CITY OF LA VISTA
MAYOR AND CITY COUNCIL REPORT
DECEMBER 19, 2017 AGENDA

Subject:	Type:	Submitted By:
APPLICATION TO AMEND PUD SITE PLAN – LOTS 14-A AND 15-A, SOUTHPORT EAST REPLAT EIGHT AND LOTS 1-4, SOUTHPORT EAST REPLAT NINE (SOUTHPORT PKWY & EASTPORT PKWY)	◆ RESOLUTION ◆ ORDINANCE RECEIVE/FILE	CHRISTOPHER SOLBERG CITY PLANNER

RE: Proposed Securities American Expansion & Offsite Parking Lot Facility
Amendments to PUD Plans-Ordinances 1020 and 1045

Exhibit D1

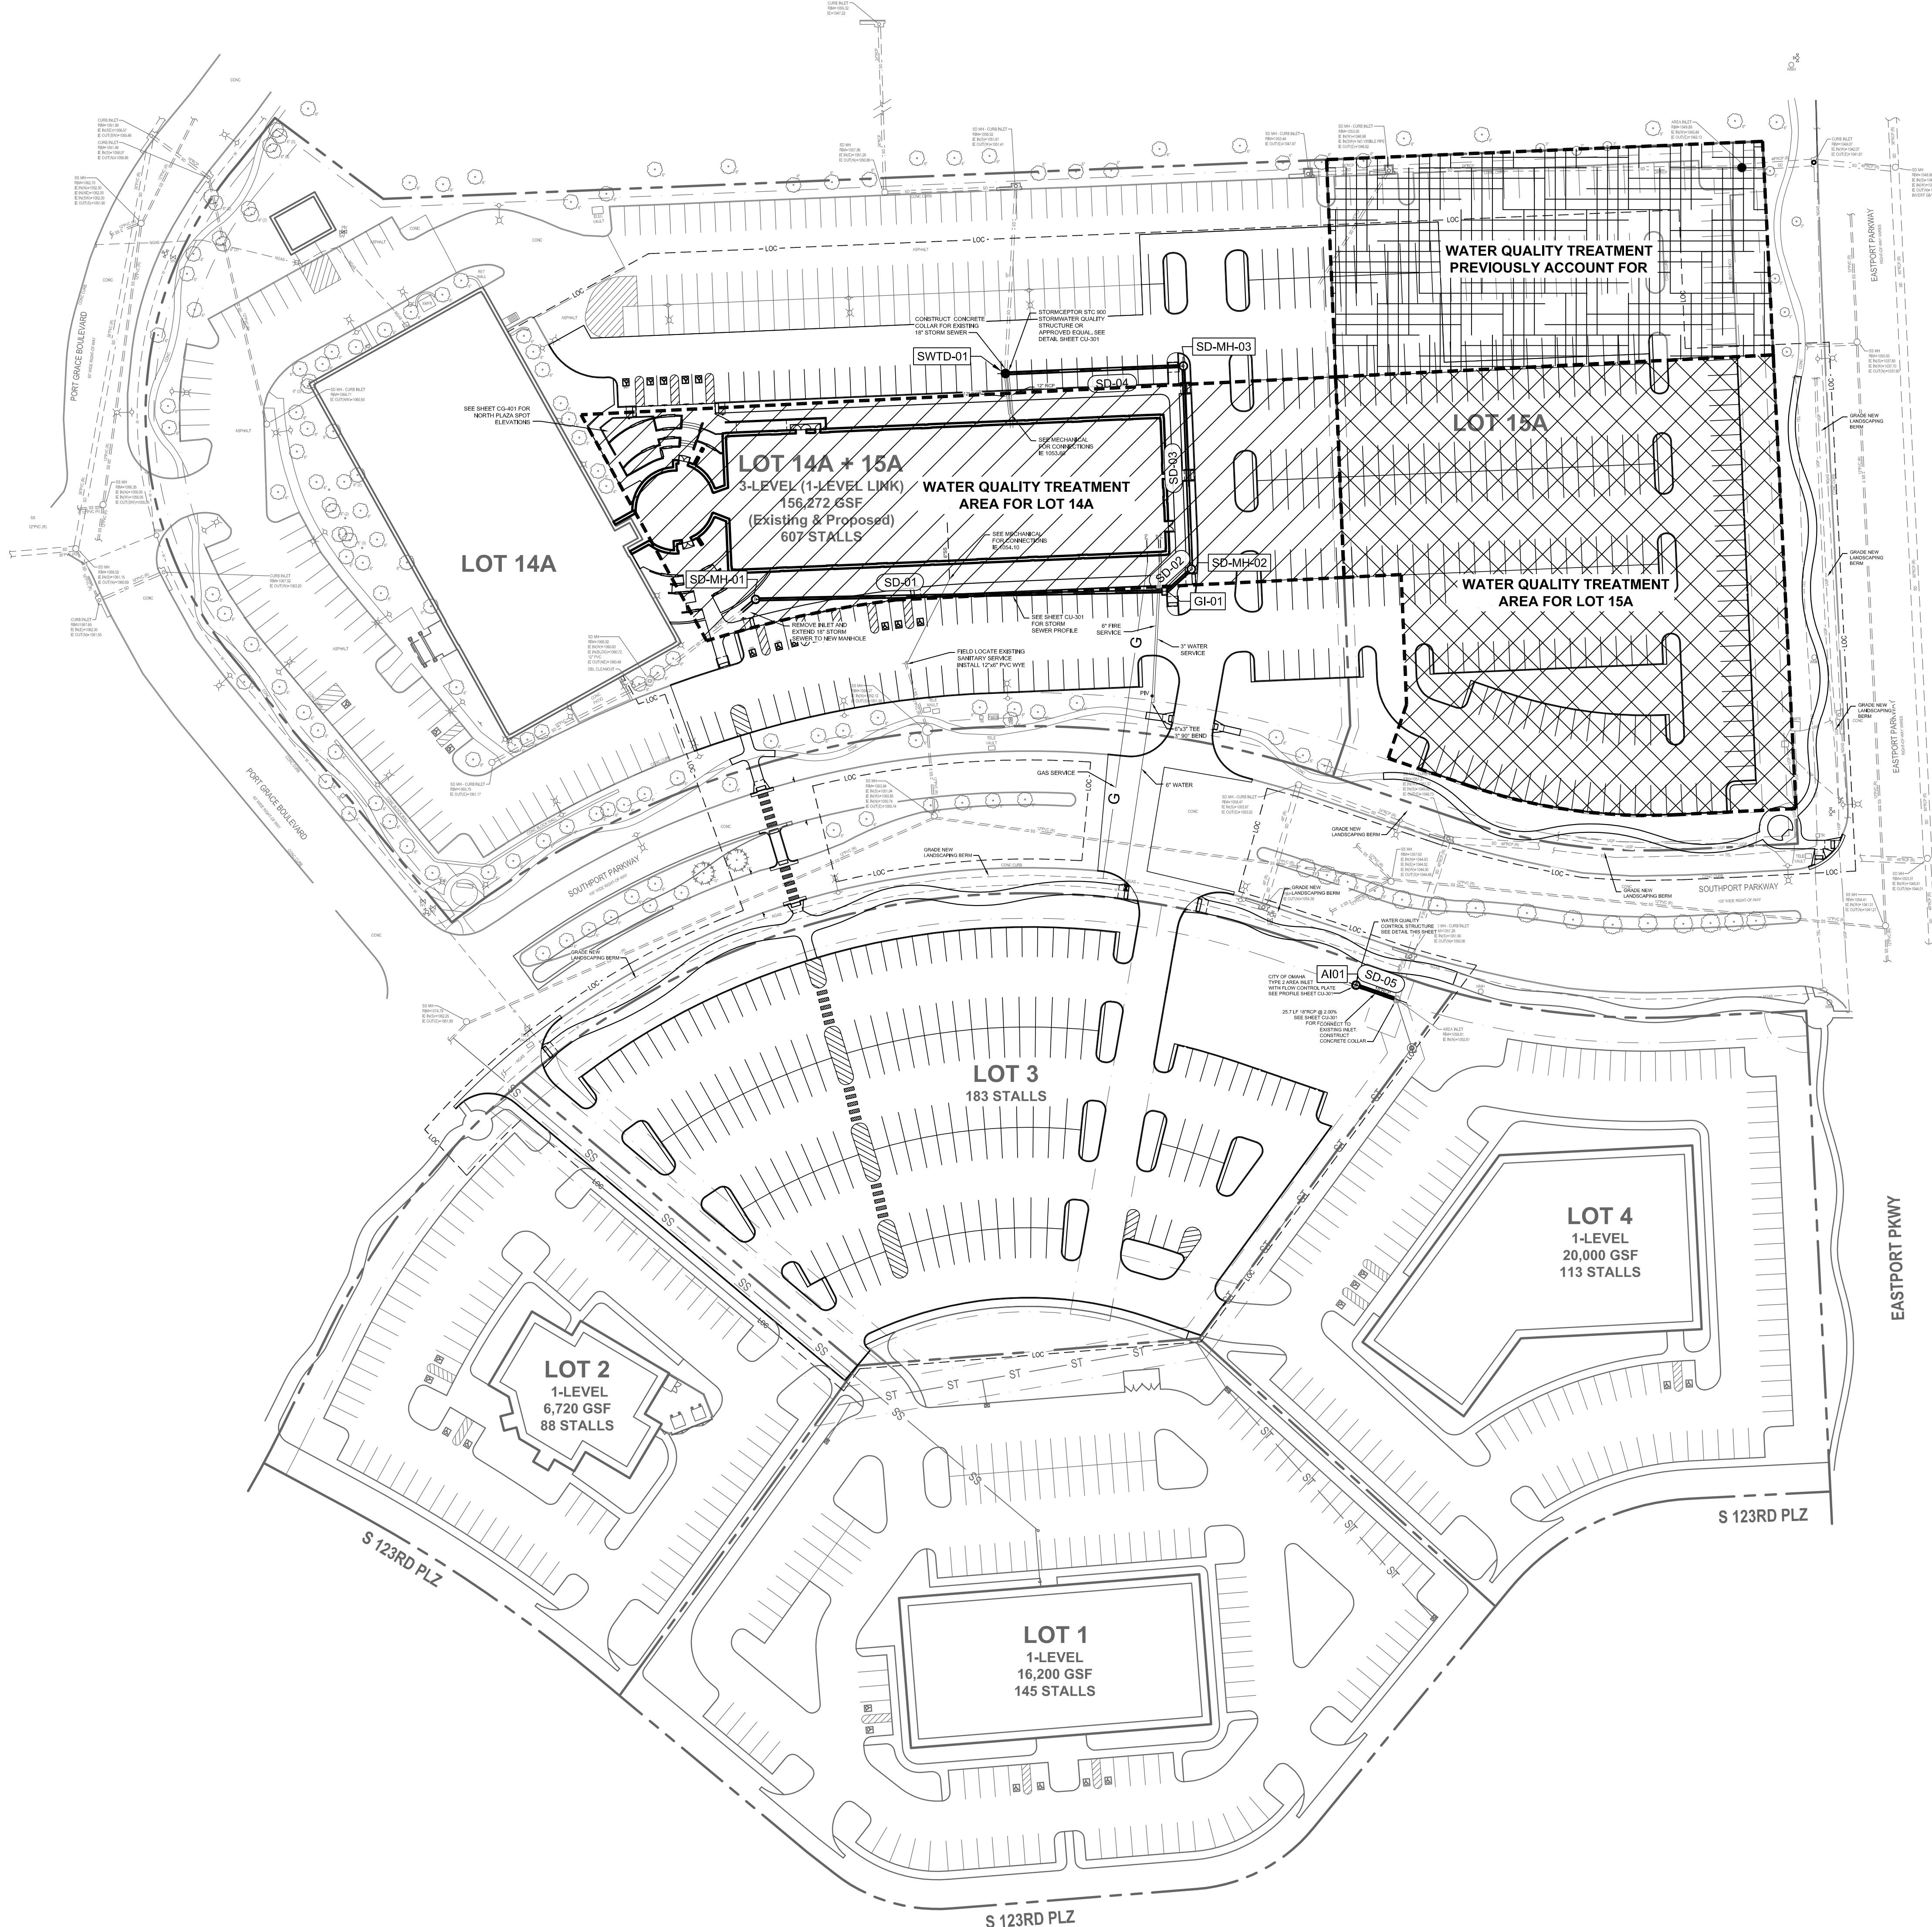
18. Article 5.15.05.04: See Item 6a above. Also, revise Exhibit D1 to show the portion of Lot 14A and 15A that will need to receive water quality treatment for compliance with Chapter 154 of the La Vista Municipal Code for new impervious surface and significant redevelopment. With this letter is an exhibit of what portion the City Engineer interprets as coming under this requirement.

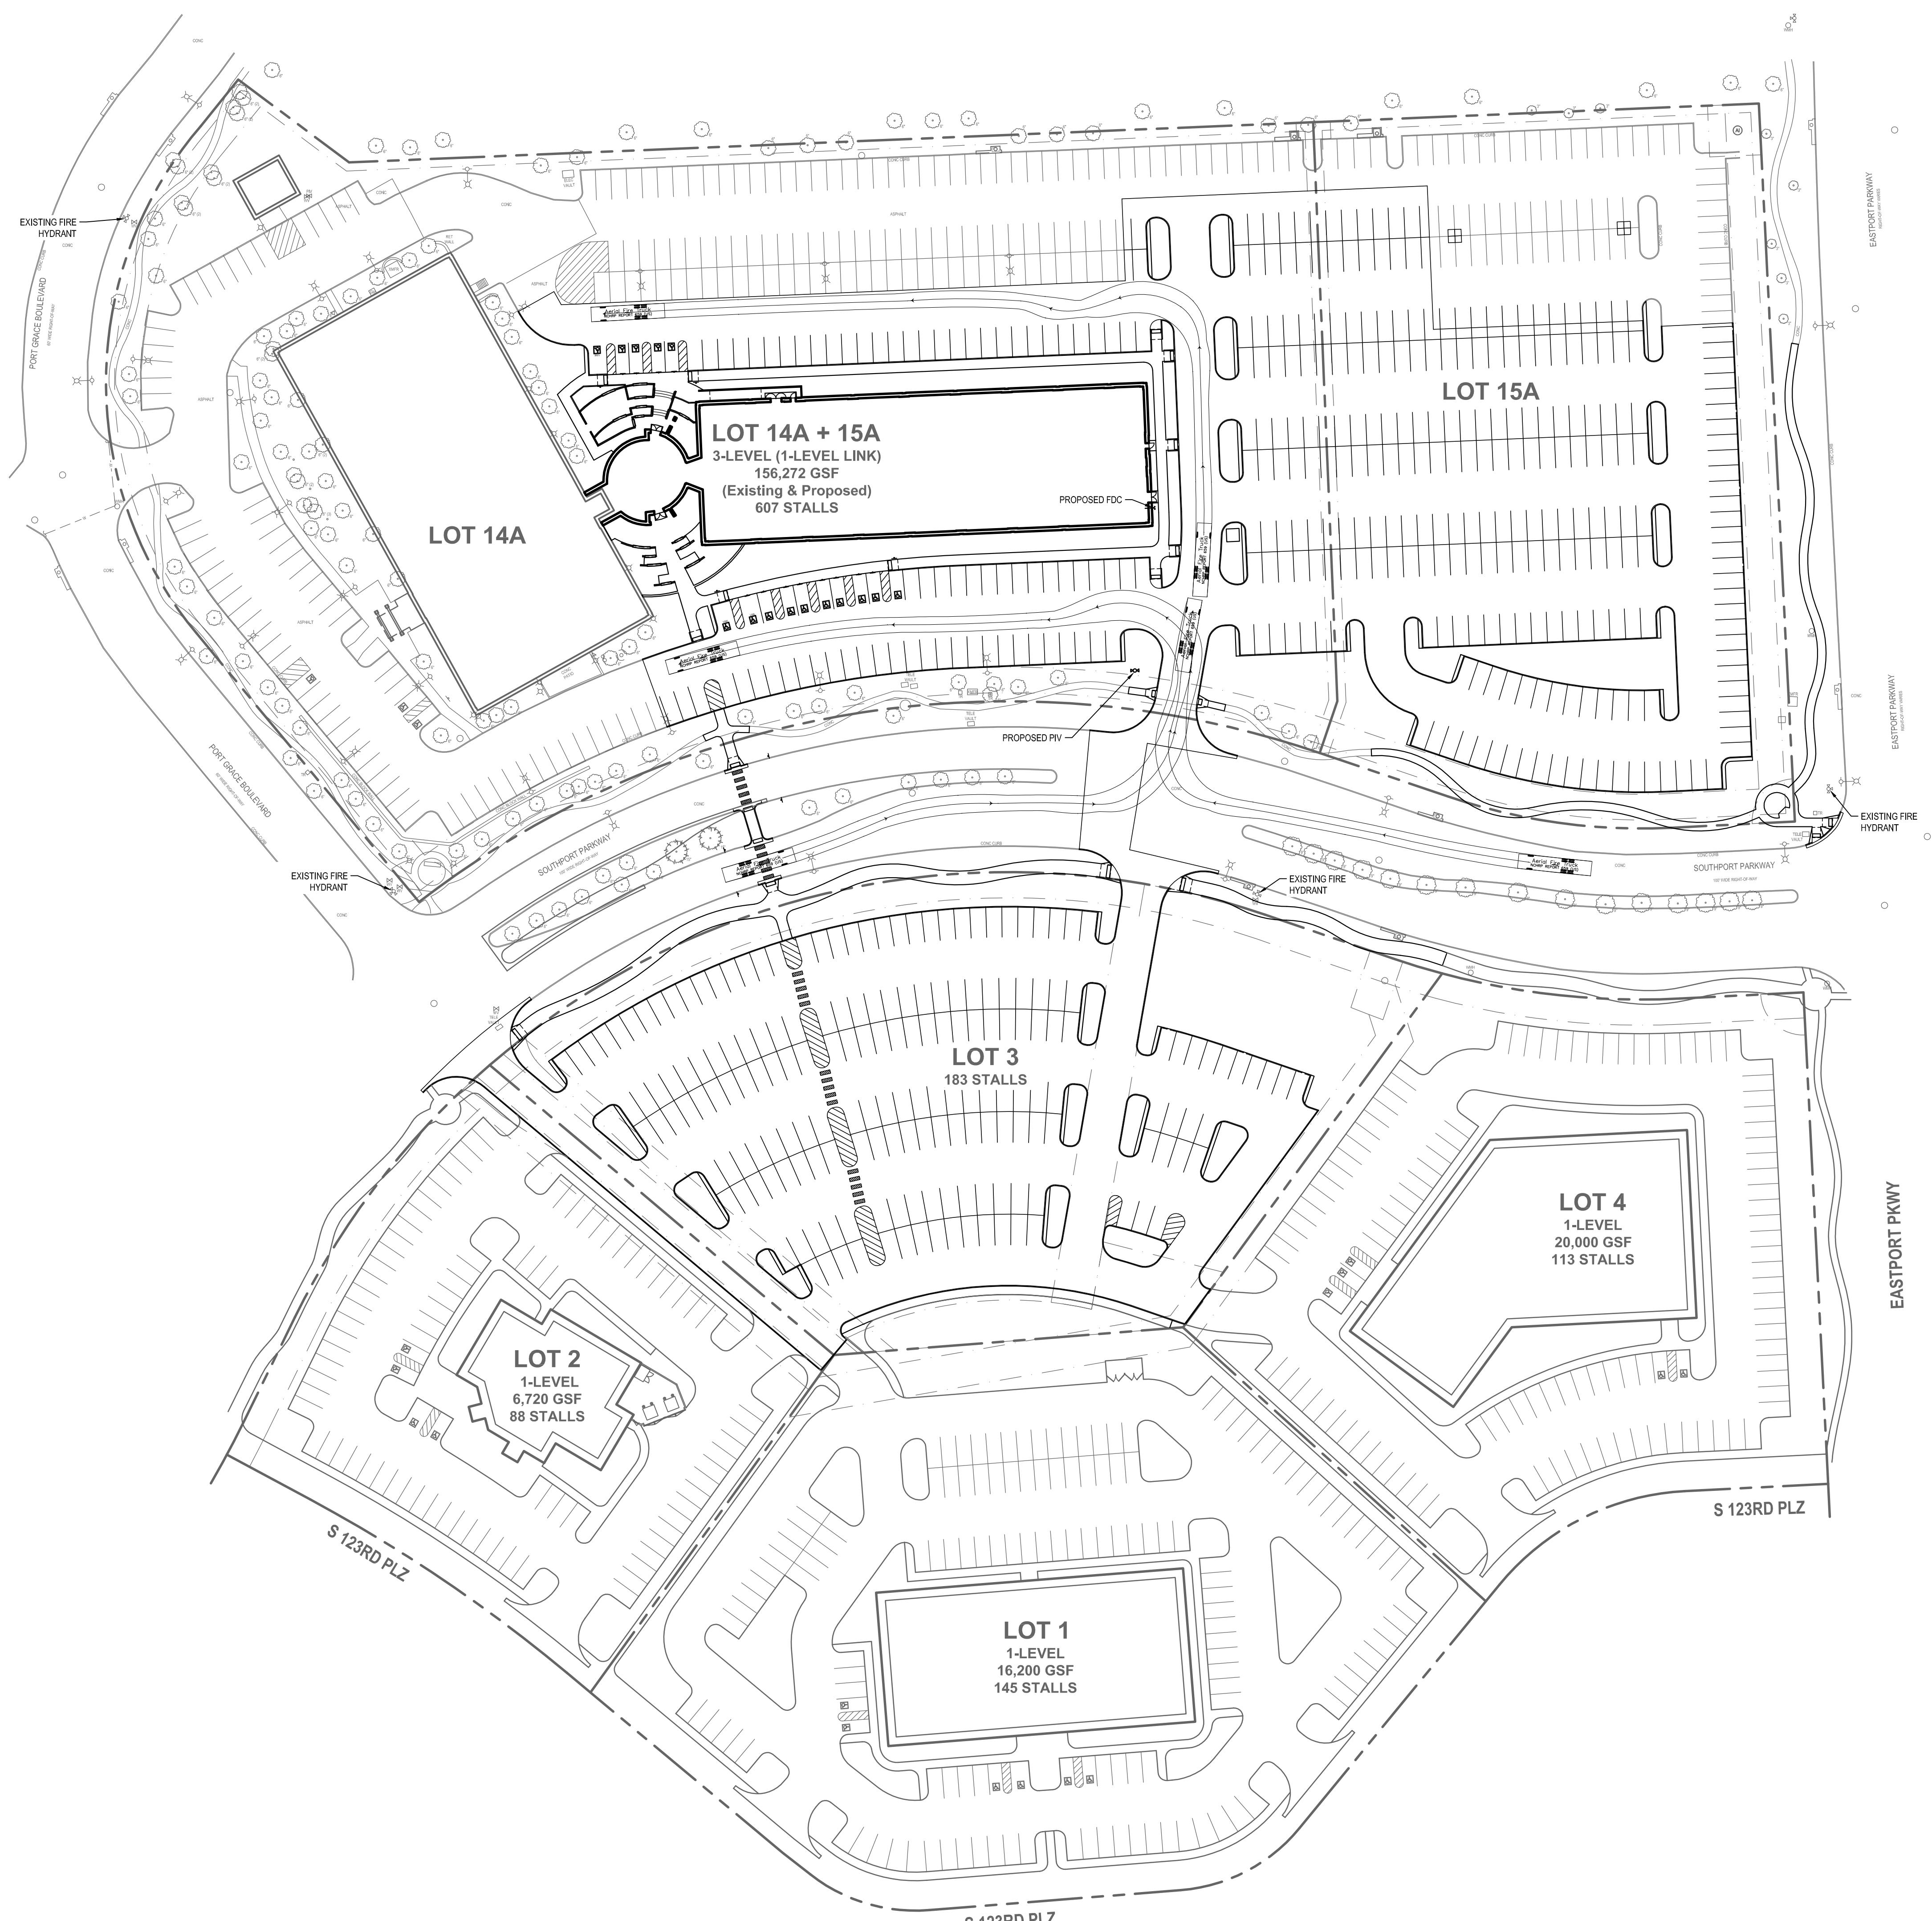
4. Article 5.15.04.04: Exhibit "E" has been provided to the Fire Marshall for review and comment. Comments are expected within the next 24-48 hours and will be forwarded upon receipt.

4. Article 5.15.04.04: Exhibit "E" has been provided to the Fire Marshall for review and comment. Comments are expected within the next 24-48 hours and will be forwarded upon receipt. **See Note 8 on Exhibit A.**
